# Leland Reservoir Replacement Project Final Environmental Impact Report

## Volume III – Responses to Comments

SCH #2016082082

Volume III

Figure 9-2: Revised Conceptual Design

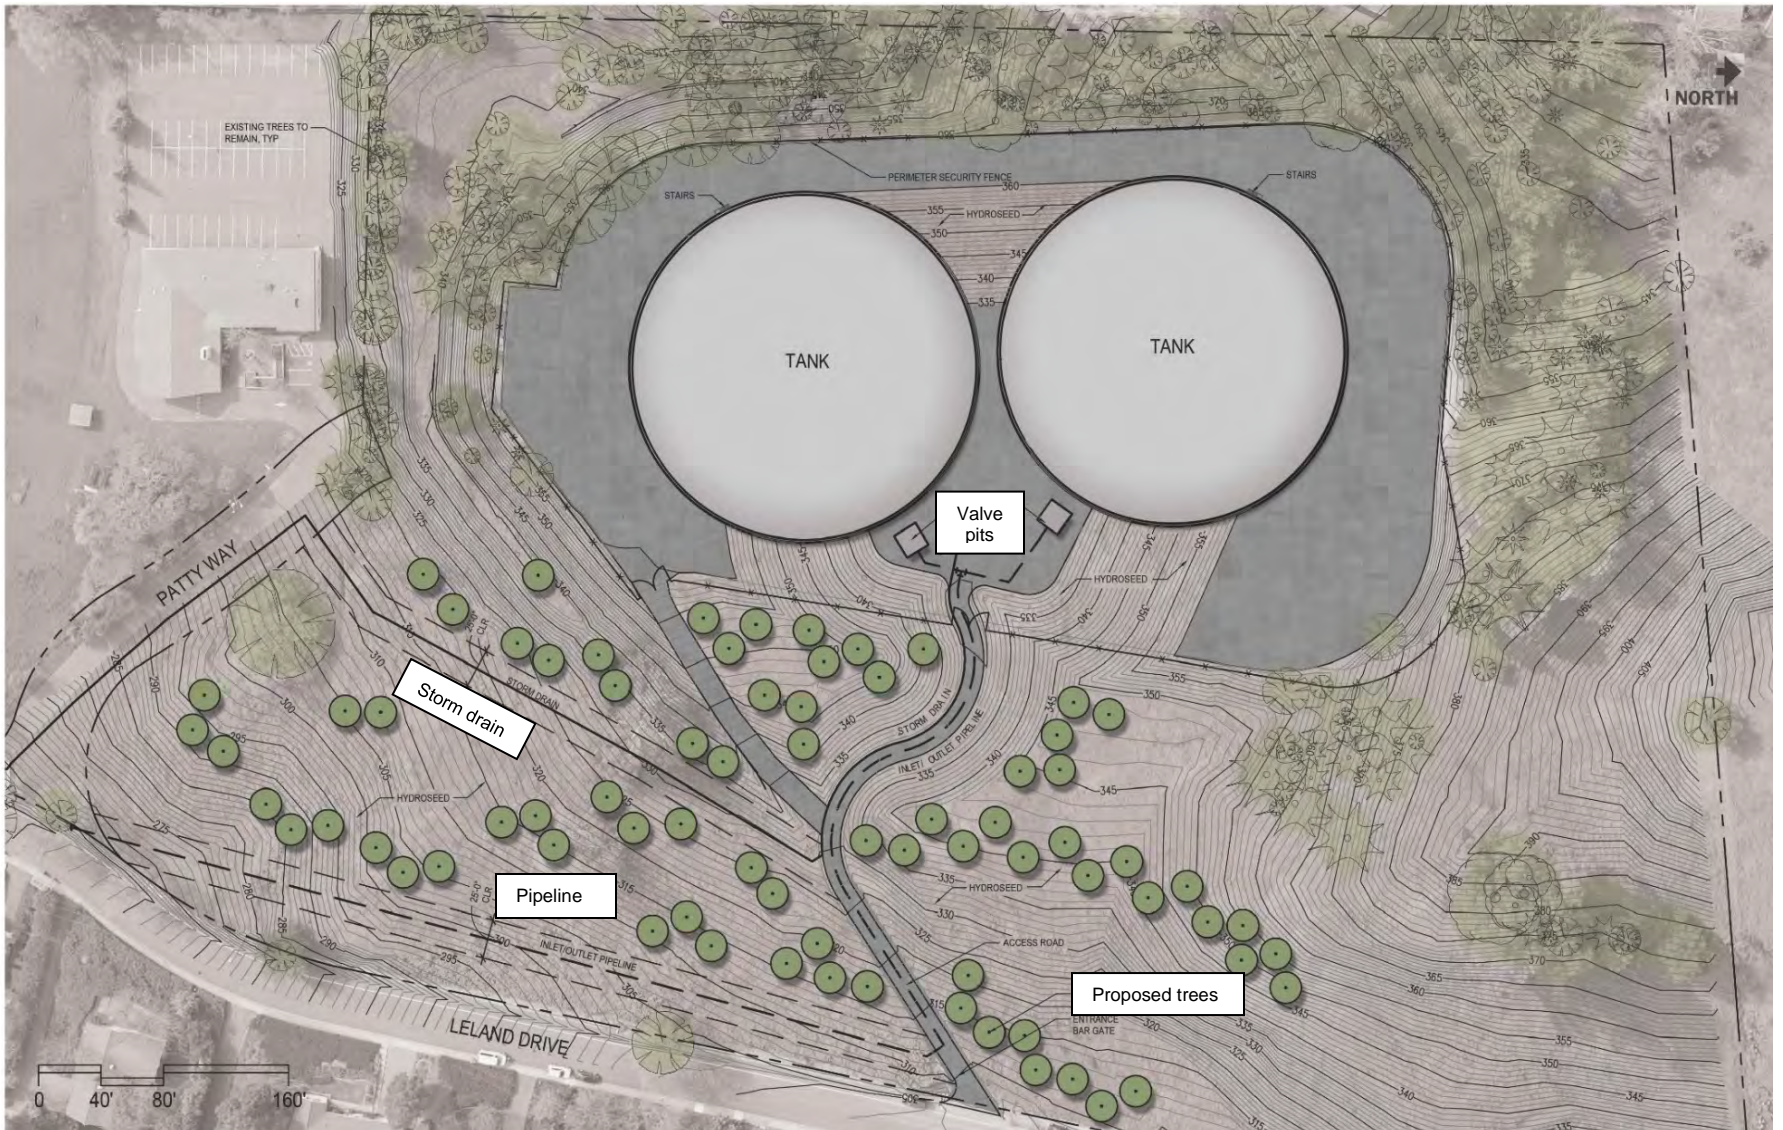
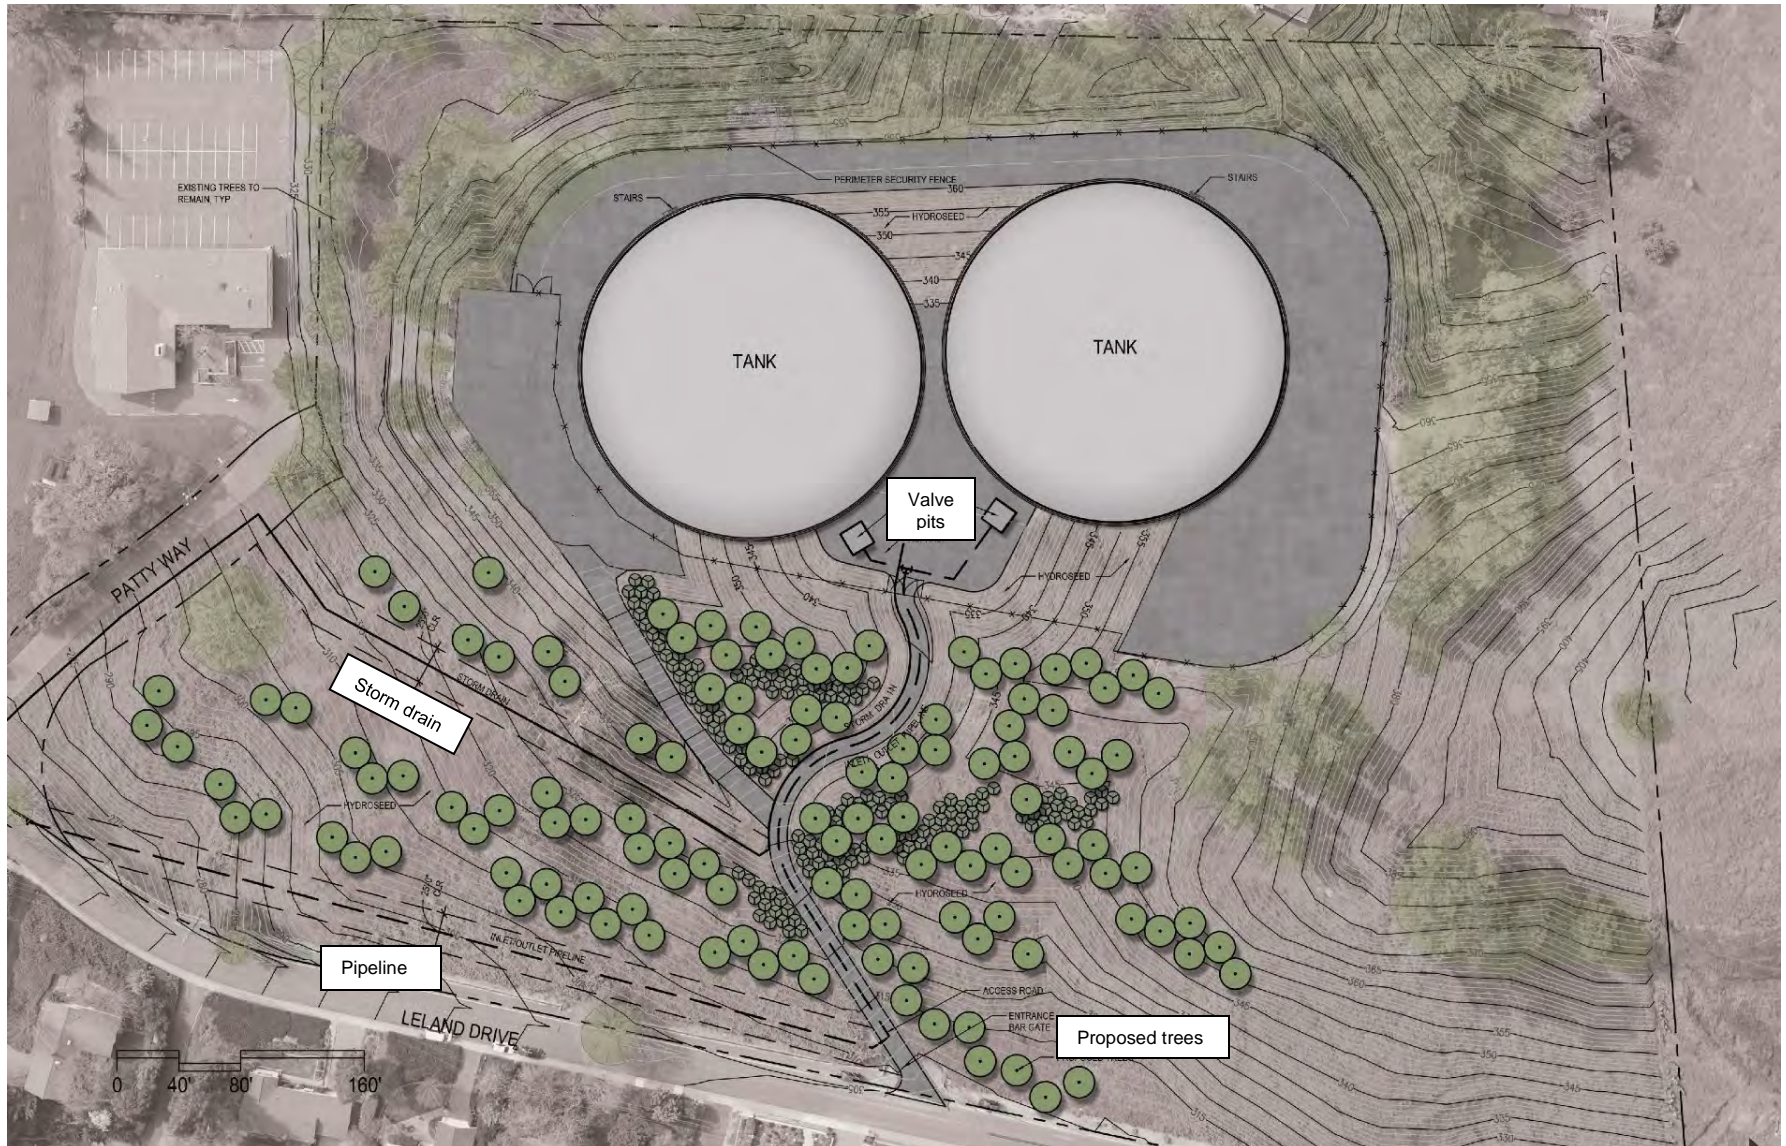
Comments suggested planting of additional trees and shrubs to provide additional screening, expressed concern about whether the selected viewpoints provided an accurate representation of the visibility of the tanks from Leland Drive and requested simulations depicting conditions immediately following construction. Photo-realistic visual simulations of the Project were presented in Figures 3.1-2 and 3.1-3 on pages 3.1-9 and 3.1-10 of the Draft EIR. At the request of the City of Lafayette and local residents, these simulations have been updated to show additional viewpoints and to document the appearance of the Project site immediately following construction. Updated visual simulations are presented at the end of this Master Response starting on page 9-9. These updated visual simulations confirm the Draft EIR's conclusion that the aesthetic impacts would be less than significant. Nonetheless, to address community concerns, EBMUD used visual simulations of conditions immediately after construction to refine the proposed Project design and landscaping plan as follows:

- Plant 50 additional trees to provide additional screening for a total of 125 trees, which would replace all of the trees removed for construction.
- Plant fast-growing shrubs along ridge lines to provide additional screening.
- Move the black vinyl security fence surrounding the tanks closer to the tanks to reduce visibility of the fence.
- Replace the existing barbed wire perimeter fence along the property line with a wire mesh fence.

Revisions to the grading plan were considered, but site constraints do not permit substantial regrading of the site, and the proposed landscaping changes listed above provide substantial screening for the new tanks. Figures 9-1 and 9-2 show the reservoir conceptual plan presented in the Draft EIR, and the plan as revised to provide additional visual screening (see next page of this Master Response).

EBMUD has revised the landscaping plan (see **Figure 9-2 on page 9-3**) to address concerns about visual impacts of the Project immediately following construction, when trees are immature, and has included additional planting of trees. The revised landscaping plan includes planting approximately 125 native trees, including additional plantings of trees and shrubs near the tanks. About 90 trees would be removed for construction of the Project and about 30 trees would be removed for maintenance purposes, so EBMUD is now proposing to plant more trees than would be removed. The updated visual simulations show that the landscaping plan would effectively screen the tanks, resulting in restoration of the site to its original condition to the extent feasible.

**Figure 9-3: Tree Removal**

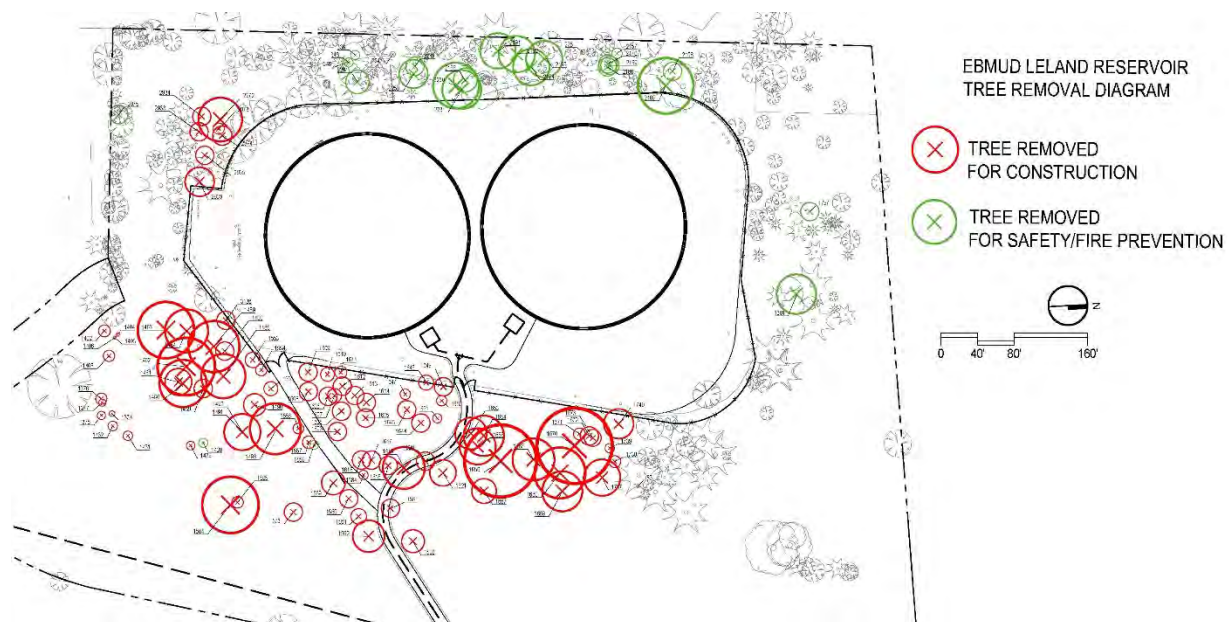
Concerns have also been expressed about the number of trees that have to be removed from the site. Restoration of the embankment would require stockpiling of soil on the reservoir site, which would be used to regrade the site after completion of construction. Because areas for storage of soil on site are limited, some mature trees would need to be removed for the soil stockpile areas, which are shown in Figure 2-9 on page 2-19 of the Draft EIR. As shown on Figure 2-9 and on Figure 2-7 (page 2-13 of the Draft EIR), EBMUD would retain as many mature trees as possible on the eastern side of the reservoir site (**Figure 9-1** on page 9-2 of this Master Response shows the same landscaping plan that was portrayed in Figure 2-7 of the Draft EIR, and **Figure 9-2** on page 9-3 of this Master Response shows the revised plan with additional trees and shrubs for screening). Existing trees, including some mature oaks, would be retained in the northeastern portion of the site, immediately adjacent to Leland Drive, and adjacent to Patty Way. **Figure 9-3** (below) shows trees that would have to be removed for construction, and trees that are being removed for safety or fire prevention as part of EBMUD’s ongoing maintenance program.
